ADDENDUM NO. 2

VILLAGE OF COVINGTON Wastewater Treatment Plant Improvements Phase II Blower Replacement February 19, 2019

Re: Village of Covington
Wastewater Treatment Plant Improvements Phase II – Blower Replacement

NOTE:
1. SEAL OFF ANY PENETRATIONS THROUGH THE FLOOR BEFORE CONCRETE.
2. OWNER TO REMOVE INTERIOR BUILDING EQUIPMENT PRIOR TO CONSTRUCTION.

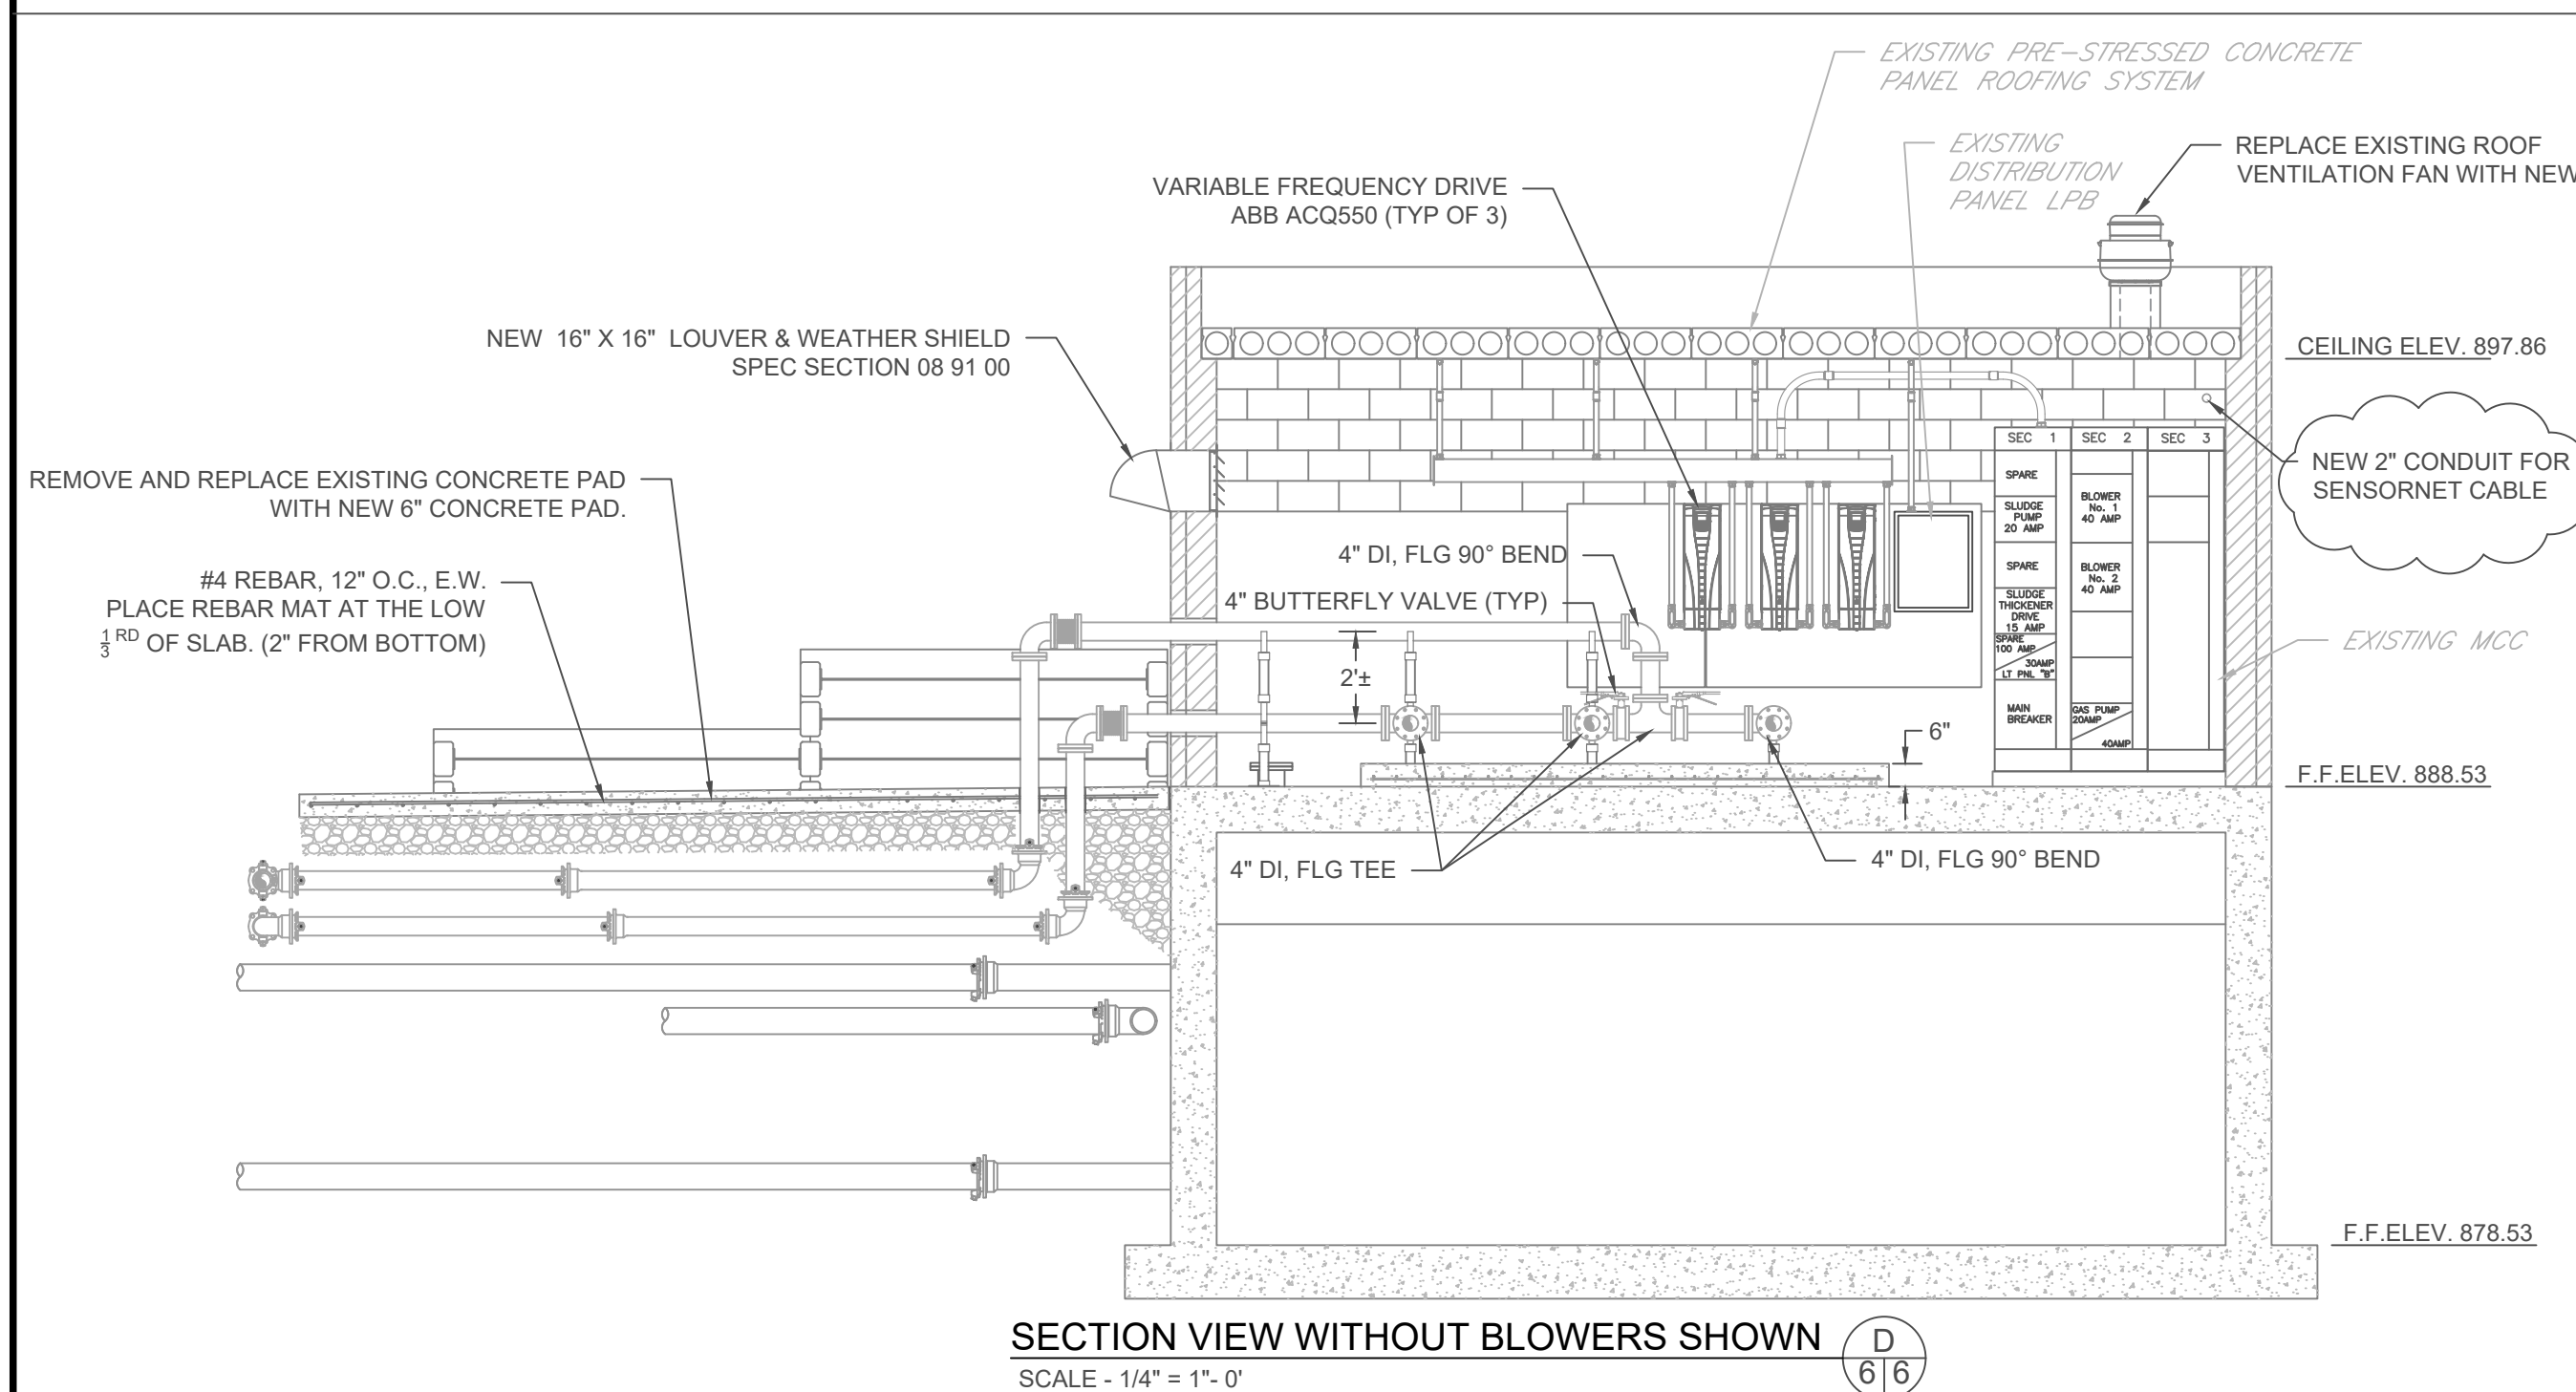
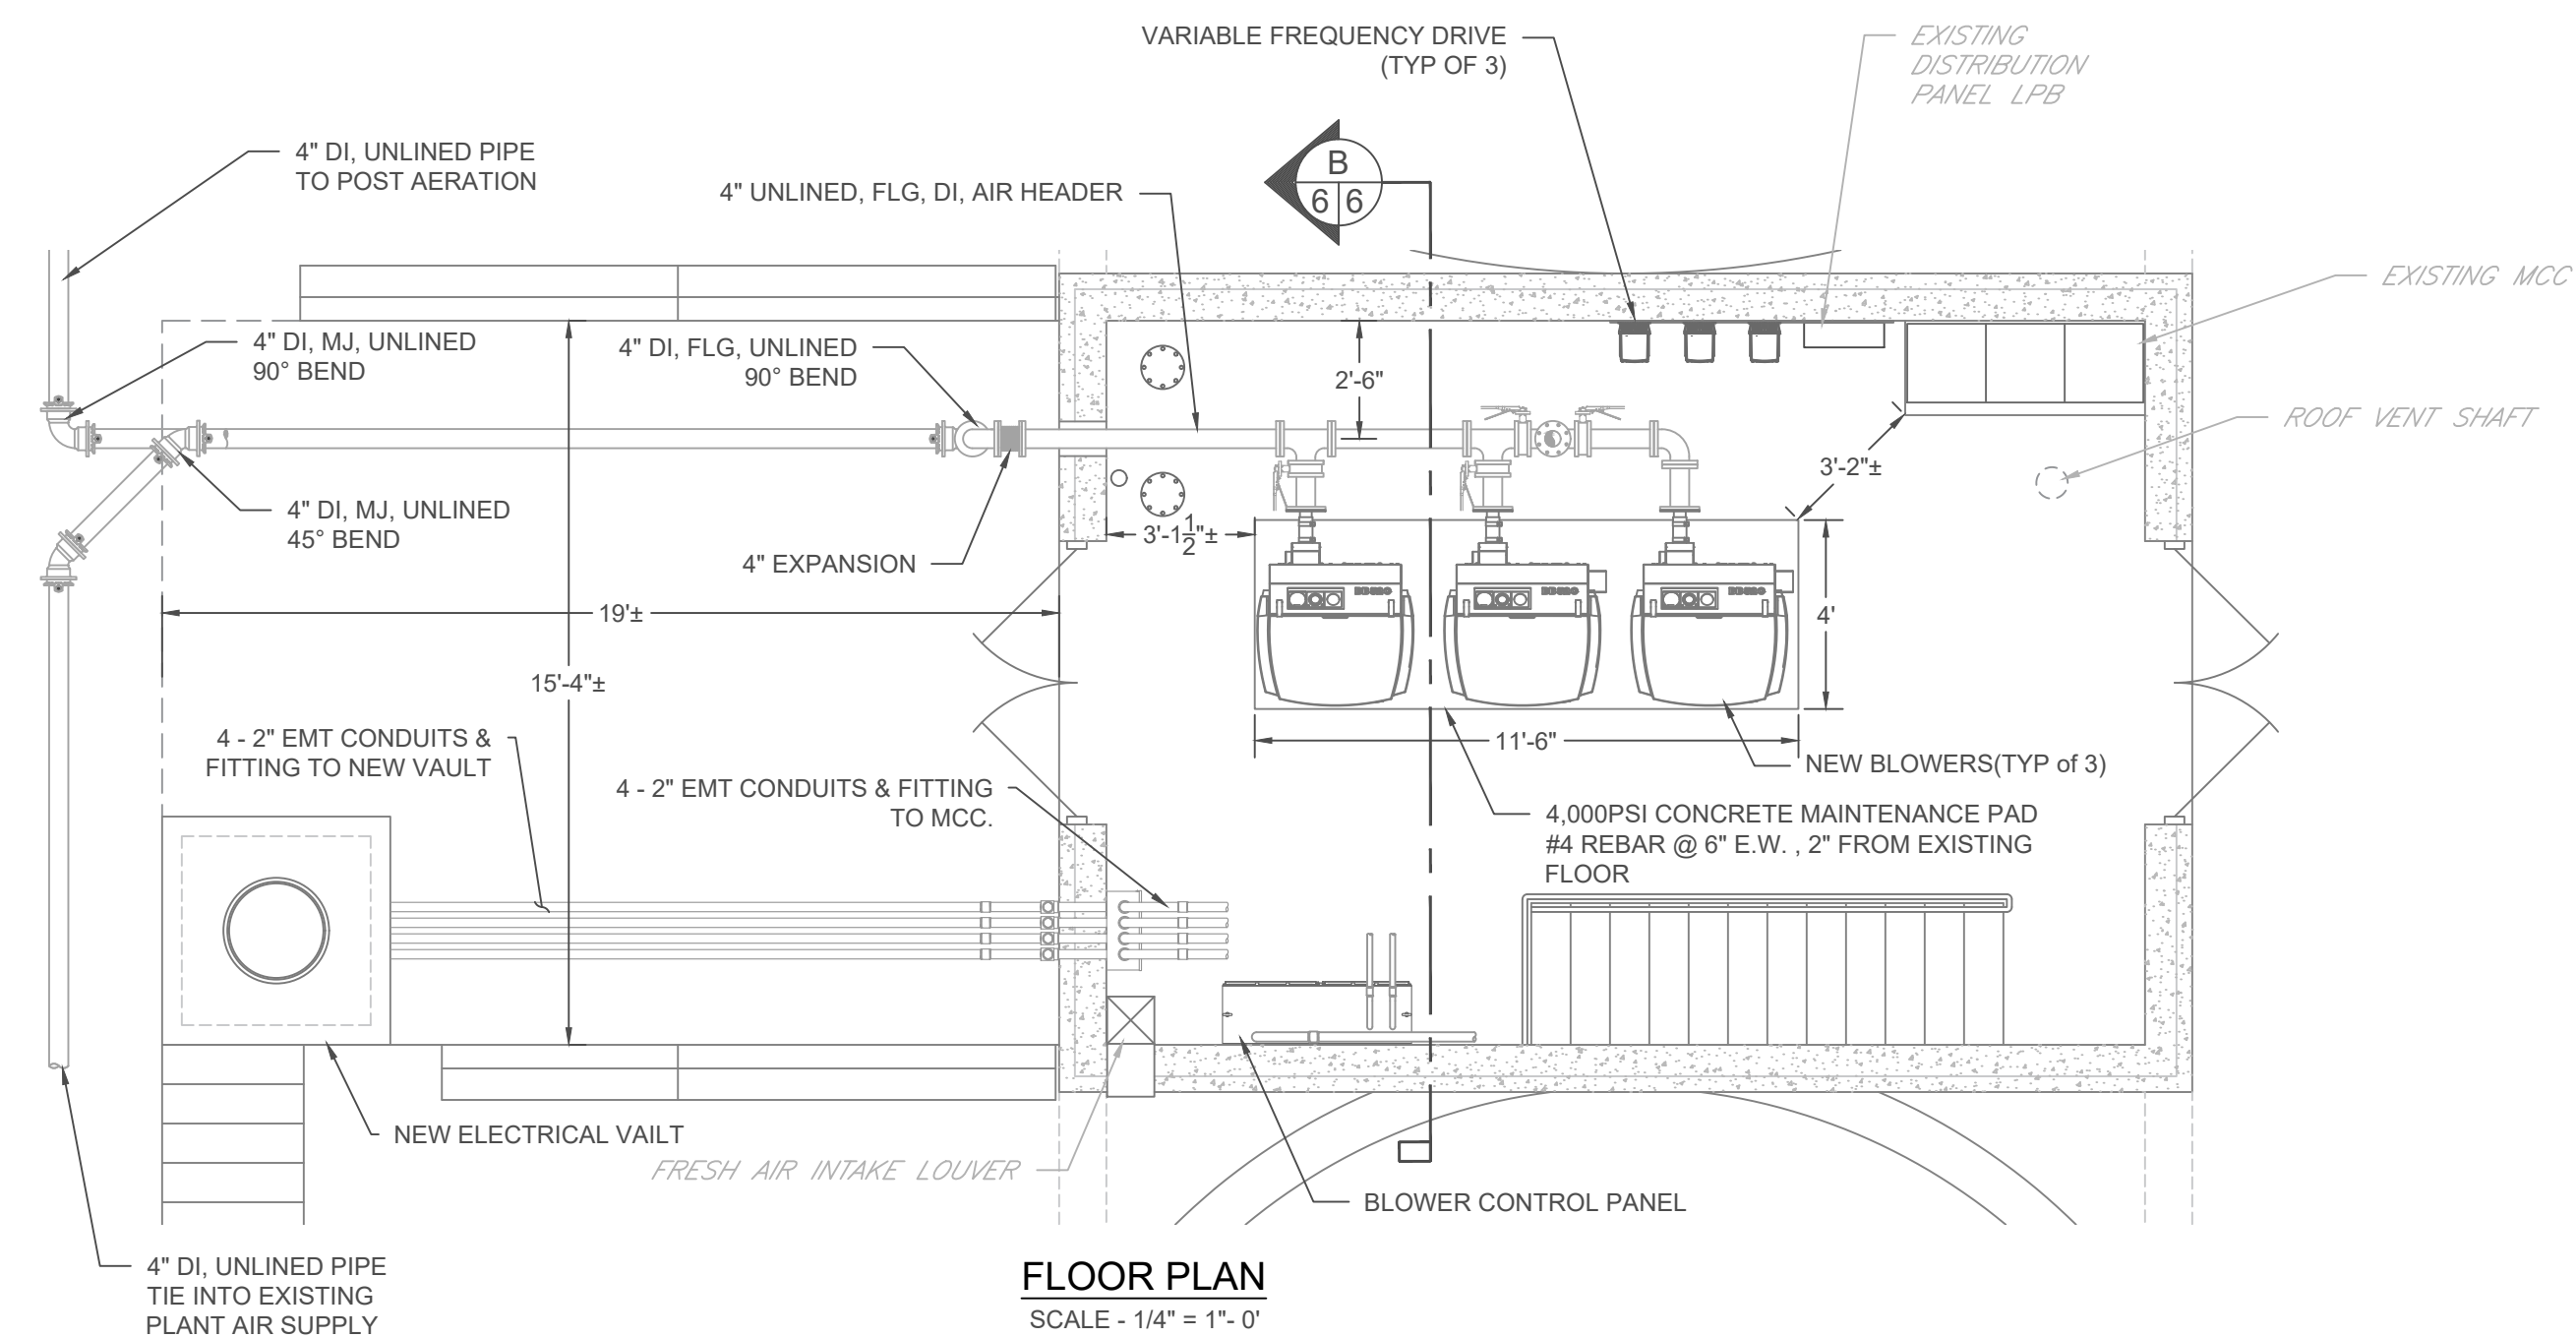
3. Sheet 2A has been updated indicated the amount of air piping to be replaced.
4. Sheets 3A, 4A, 6A, 8A and 9A indicate the changes from fiber-optic to SensorNet Cables.
5. Sheet 5A clarifies the water piping and obsolete equipment to be removed.

DRM	15 FEB 2019	REMOVE FIBER-OPTIC AND REPLACE WITH YSI SENSORNET
-----	-------------	---
